In the Matter of
SACRAMENTO MUNICIPAL UTILITY DISTRICT
(Rancho Seco Nuclear Generating Station)
Docket No. 50-312 (SP)

REVIEW OF THE RANCHO SECO NUCLEAR GENERATING STATION
UNIT NO. 1 AUXILIARY FEEDWATER SYSTEM RELIABILITY ANALYSIS

This report presents the results of a review of the Auxiliary Feedwater System Upgrade Reliability Analysis for the Rancho Seco Nuclear Generating Station Unit No. 1. The objective of this report is to estimate the availability of the Auxiliary Feedwater System when required to perform its mission for each of three different initiators: (1) loss of main feedwater with off-site power available, (2) loss of offsite power, (3) loss of all 4160 VAC power. The scope, methodology, and failure data are prescribed by NUREG-0611, Appendix III. The results are compared with those obtained in NUREG-0611 for other plants.

Figure-1

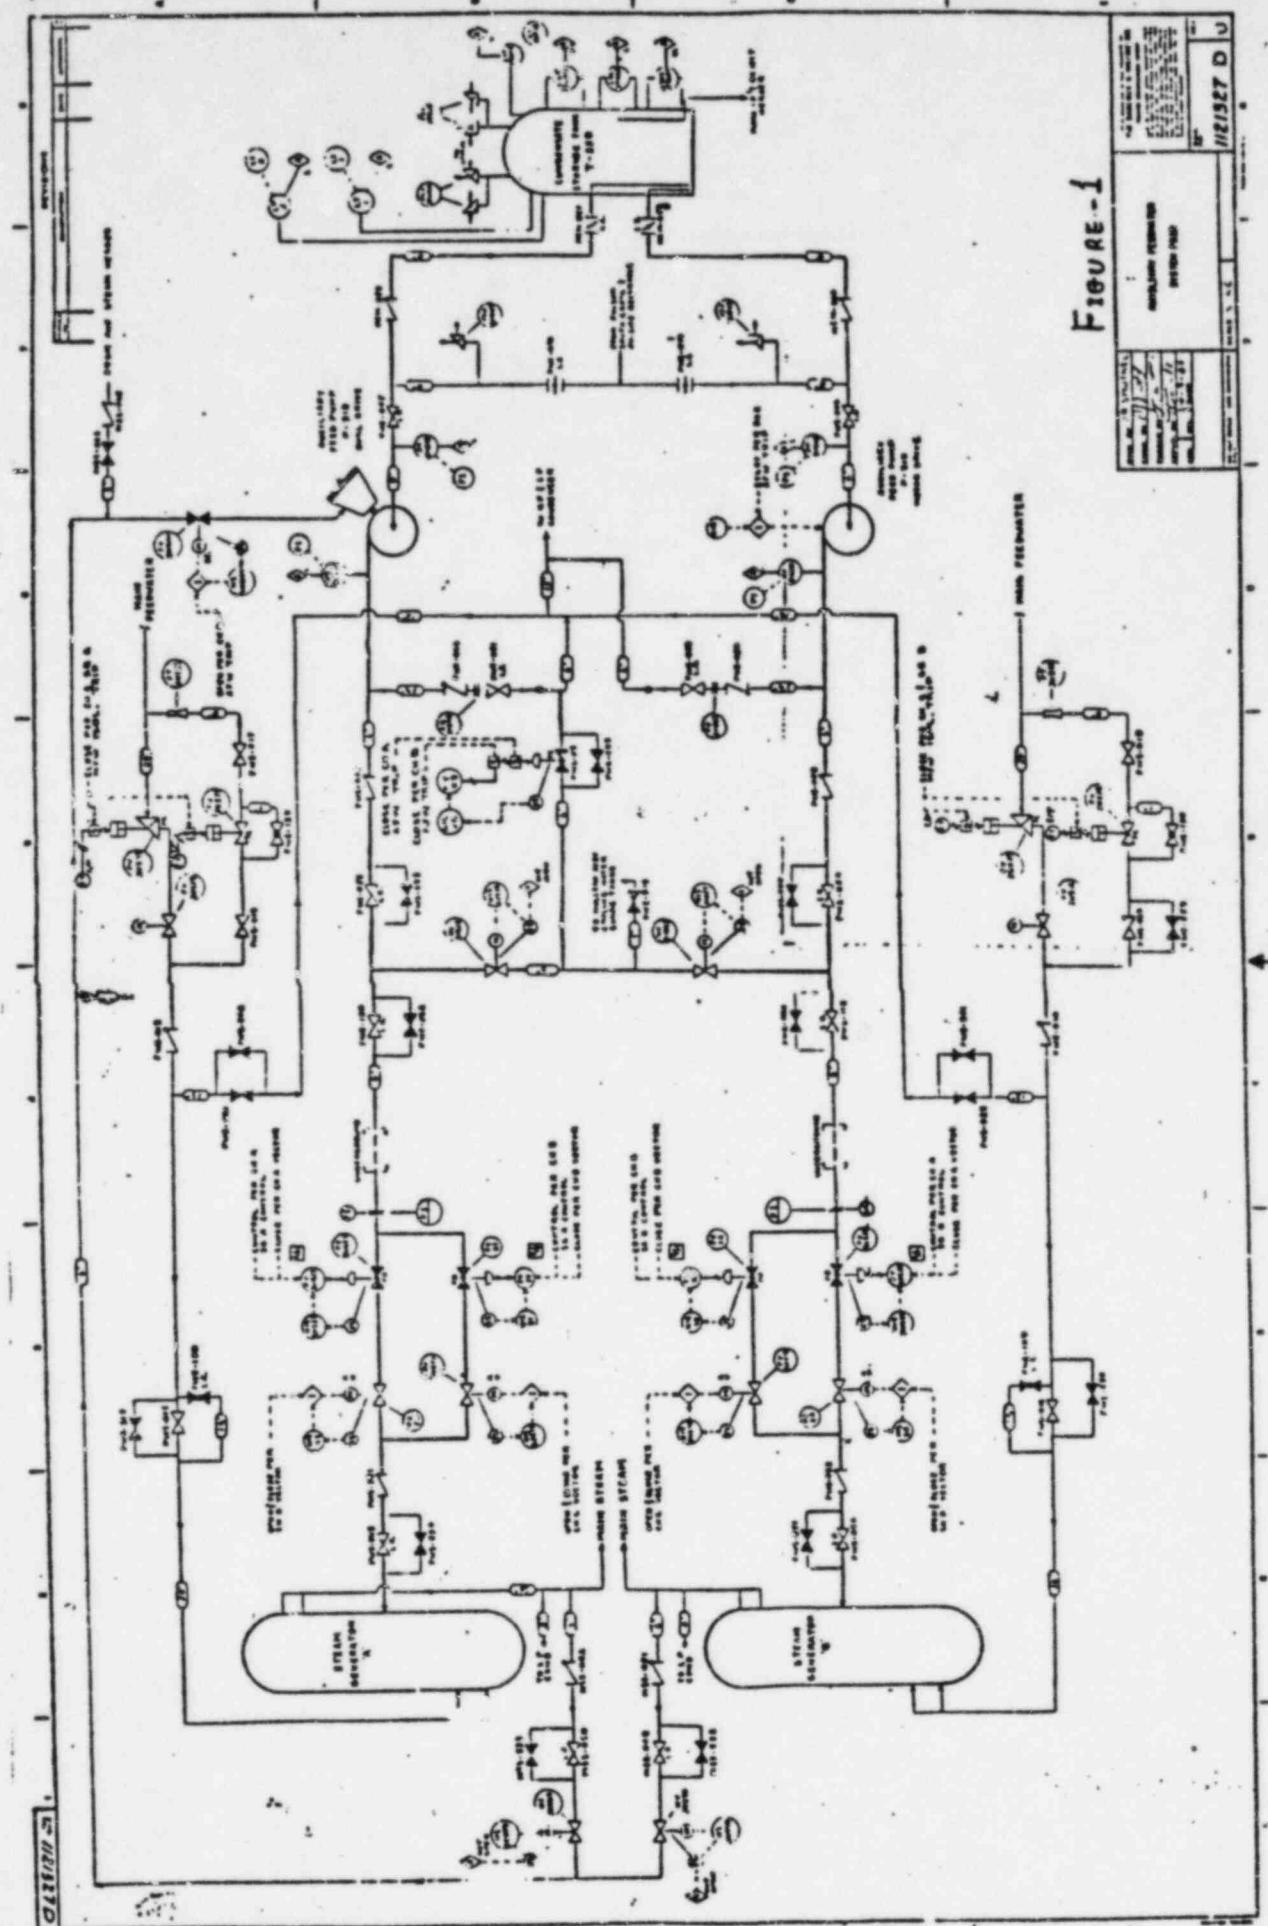
RS-1's AFW system (Figure -1) consists of two pump trains. Each pump has a separate suction line originating from the Condensate Storage Tank. The two discharge lines to the two steam-generators are interconnected, allowing each train to supply AFW to either or both steam-generators (SG). AFW Train A pump (AFW-1) is a combination turbine-driven motor-driven pump with both the turbine and electric motor on a common shaft. The turbine drive is used as the primary motive source for this pump. The motor drive can be manually initiated. AFW Train B pump (AFW-2) is a motor driven pump which has the same rated capacity and recirculation flow as AFW-1. Both AFW pumps are self contained entities without dependences on secondary support systems for lubrication and for lube-oil cooling. The bearing on the turbine and both pumps are lubricated by slinging oil from reservoirs near the bearing. Lube oil cooling is accomplished by heat transfer to the pumped fluid.

There are two interconnected trains in the AFWs (see Figure 1). Each train consists of one pump and one discharge line having two control and isolation valves in parallel. A cross-connect links the two discharge lines, and permits each pump to supply AFW to one or two discharge lines. A common test line having the same diameter as the discharge line permits full flow test of both pumps. Mission success is defined as adequate flow from one pump to one SG within the appropriate time.

Event $Q_1 Q_2$ does not contain any significant single failures. Likewise event $A * B$ does not contain single failures. Event D includes the single test valve FWS-X5. A passive failure of this valve will open a flow path for both AFW trains which will bypass both steam generators. This path is 6" in diameter, the same diameter the discharge lines have. A passive failure with a failure rate of $10^{-7}/\text{hr}$ is assumed according to WASH-1400. It may yield a common mode failure probability of 10^{-4} , if special surveillance actions for this failure mode of the valve, are not taken during the period between regular maintenance schedules (assumed equal to 4.5 month per NUREG-0611).

If lack of recirculation can fail the AFW pumps, then this is another potential single failure. This is because in the "small lines" connecting the recirculation lines to the condenser, there may be some common lines with locked open valves. The SMUD report does not contain sufficient information to conclude whether such common valves do exist. If such valves exist then NUREG-0611 guides to use a flow blockage value of 1×10^{-4} for each valve even if it is locked open. While a value of 10^{-4} may be somewhat conservative for flow blockage, it is not considered to be overestimating the probability of leaving locked open valves closed following maintenance activities.

Failure of Test Line: Failure of the test line valve is a potential single failure that can cause AFW flow diversion and consequently dryout of steam-generators. SMUD has made a considerable effort to remove the possibility of the valve being left open after test. By adding automatic closure of this valve upon automatic initiation of AFW using signals from both Channels A and B of EFIC, this mode of failure was practically eliminated. However, there is also a potential for failure of the valve to reset, or passive mechanical failure of the valve that allows gross leakage. It is difficult to prove that the probability of this failure mode is less than 10^{-5} per year. Thus, it becomes a significant contributor. BNL used a value of 10^{-4} for gross leakage from this single valve, i.e., $1/3$ of the mechanical failure rate given by NUREG-0611 for air operated valves.
